AMENDMENTS TO THE DRAWINGS:

#### REMARKS

**FIG. 1A**

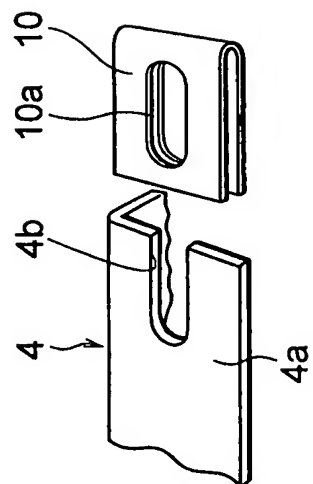
Please substitute the attached replacement sheets for Figures 1A and 5 of the drawings as originally filed. Annotated sheets showing the changes are also provided herewith.
